Access Compliance Report

Public Rights-of-Way

Intersection ID: 52609	Main Street: SENATOR ROYALL DR	Cross Street: ALEXANDER VILLAGE MAIN DR	Location: SE
ADA ID: 87DEB739DEB6	Ramp Type: BlendTrans1	Initial Pass/Fail: Fail	Overall Compliance: No
		Severity Score: 1.25

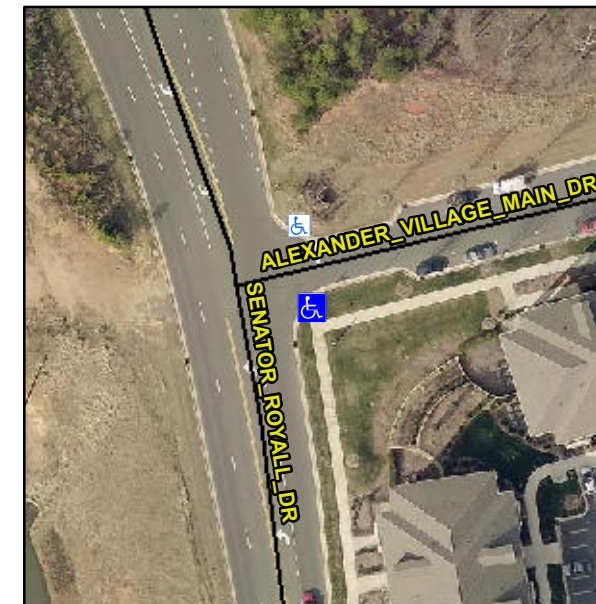
Compliance	Description	Data	Compliance	Description	Data
N/A	Ramp Length (in)	122.0	Yes	BlendTrans Slope (%)	4.9
Yes	Ramp Width (in)	62.0	No	BlendTrans XSlope (%)	2.9
N/A	Flare Type L	Curbed_NoWalkSurface	N/A	Flare Type R	Curbed_NoWalkSurface
N/A	Flare Slope LT (%)	N/A	N/A	Flare Slope RT (%)	N/A
N/A	Flare Traversable LT?	No	N/A	Flare Traversable RT?	No
N/A	Landing Length (in)	66.0	N/A	DWS Provided?	Yes
N/A	Landing Width (in)	78.0	N/A	DWS Contrast?	Yes
N/A	Landing Slope (%)	0.5	N/A	DWS Length (in)	24.0
N/A	Landing X Slope (%)	2.3	N/A	DWS Full Width?	Yes
N/A	Landing Curb? (Y/N)	No	N/A	DWS Offset (in)	N/A
N/A	Shared Landing?	No			
N/A	Gutter Ponding?	No	N/A	Gutter Slope (%)	1.3
N/A	Gutter Lip Ht (in)	0.0	N/A	Gutter X Slope (%)	1.9
N/A	Painted X Walk1?	No	N/A	Painted X Walk2?	N/A
	X Walk 1 Direction	To N		X Walk 2 Direction	N/A
	X Walk 1 Width (in)	N/A		X Walk 2 Width (in)	N/A
	X Walk 1 Slope (%)	0.2		X Walk 2 Slope (%)	N/A

X Walk 1 X Slope (%)	4.6		X Walk 2 X Slope (%)	N/A
N/A	Ramp inside XWalk1?	N/A	N/A	Ramp inside XWalk2?	N/A
	Road Slope (%)	4.6		Clear Space?	Yes
	Road X Slope (%)	0.2	N/A	Clear Space to XWalk (in)	N/A
N/A	Any Obstructions?	No	N/A	Storm Grate/Utility Hazard?	No
	Obstruction Type			Storm Grate/Utility Type	
			N/A		N/A
			Yes	Surface Condition? (G/P)	Good
			N/A	Curb Slope (%)	N/A

Remove & Replace Curb Ramp With Two New Directional Ramps or Equivalent.

R304.5.3
